### Design Improvement – 60 Series Detroit Diesel

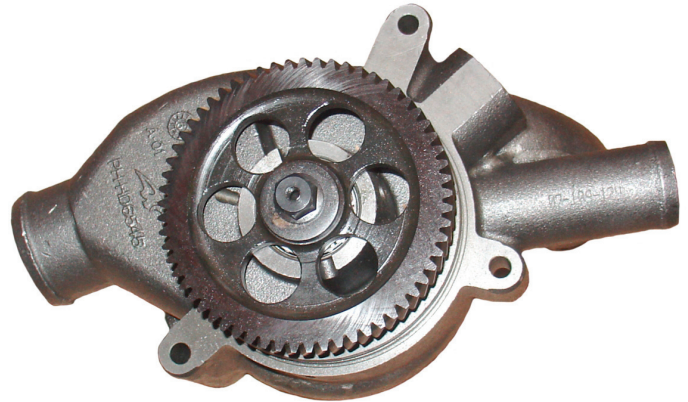
Both OE pump manufacturers and PrimaTech have added a design revision to the DD60 Series water pump to conceal normal weepage and avoid unnecessary pump replacement. It is called the weep well. A weep well is a cavity in which weepage is collected and allowed to evaporate rather than cause staining or coolant drips. If the pump's seal truly fails, the weep well will fill up and coolant will exit through a hole at the top of the well. This revision is being implemented at the production line in September 2008.
